**PUD-94
EXHIBIT B**

Subject: Roselyn Estates II Property
1623 Cindy Way – Parcel B
Pleasanton, California

RESPONSE TO PEER REVIEW COMMENTS

RE: Geotechnical Peer Review
Roselyn Estates II
Pleasanton, California

Section A-A' 2:1 Setback Reinforced

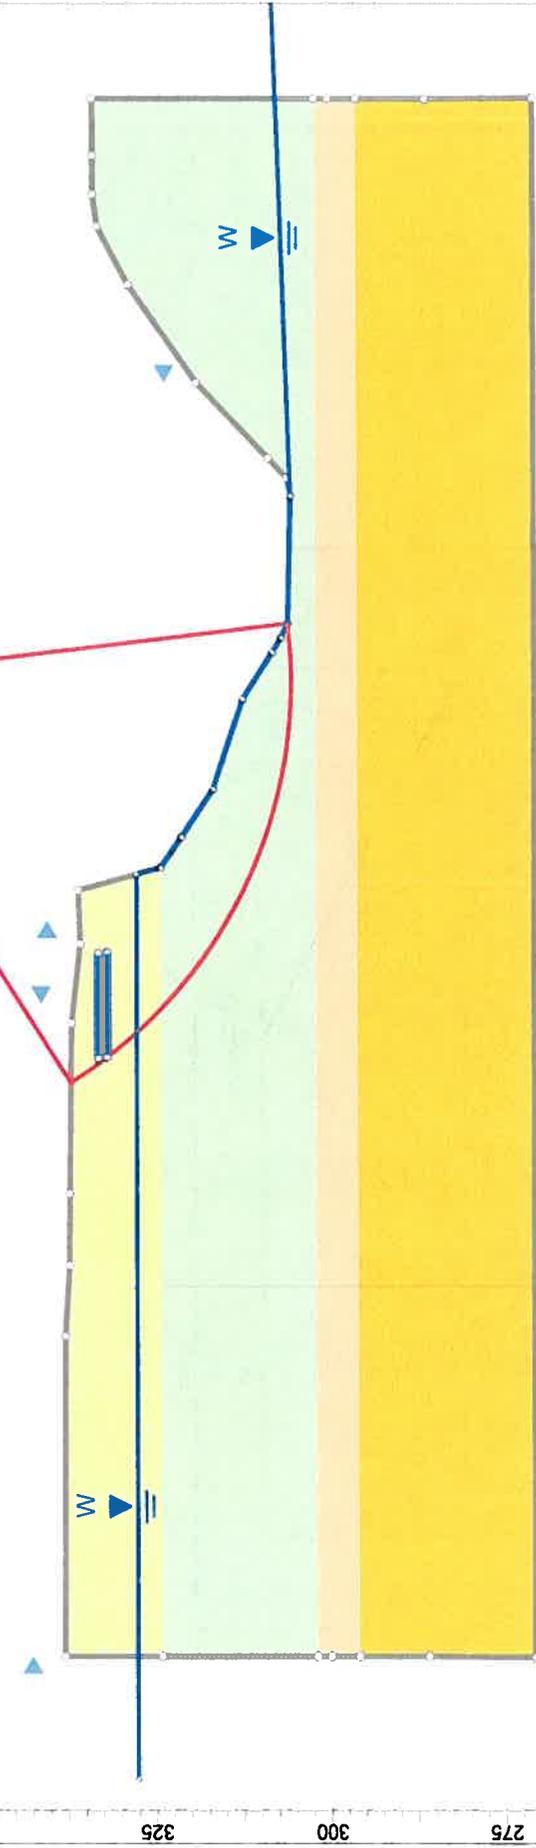
Comment 2 - Water Level in the Slope: *“The slope stability analyses indicates the water level within the slope was assumed to be at Elevation 308, the toe of the slope, for the computations. The flooding analyses indicates the water could build up to Elevation 322-327 during a 100-year event. Given the moderately permeable layers of sands and silts present along the creek, it is likely the water surface within the slope along the creek could build up to much higher than Elevation 308. Engco should perform a sensitivity study to illustrate the degradation in factor of safety with raising of water levels within the slope, and then comment on the highest reasonable levels of build-up they expect. Engco should then recommend any needed adjustments in their remedial design.”*

To evaluate the degradation in the factor of safety with raising the water levels within the slope, we modeled the water level within the slope for all four cross-sections at the highest elevation of 327 feet. The analysis indicates that the factor of safety is one or greater for the reinforced slope. It is our opinion that a factor of safety of one or greater is satisfactory given that the likelihood of the flood event is low with a short duration, in combination with the permeability of the soil that would not facilitate much infiltration for the short duration event. Table 1 below shows a comparison of the factor of safety with the water level modeled at the base of the creek bank compared to the factor of safety with the water level modeled at elevation 327 feet. The individual slope stability runs are included in the attachment. Based on our stability analyses, we do not recommend changes to the reinforcement recommendations.

CALCULATED FACTOR OF SAFETY		
Section	Water Level Base of Creek Bank (Reference 1)	Water Level at Elevation 327 feet
A to A'	1.6	1.0
B to B'	1.5	1.0
C to C'	1.6	1.1
D to D'	1.6	1.1
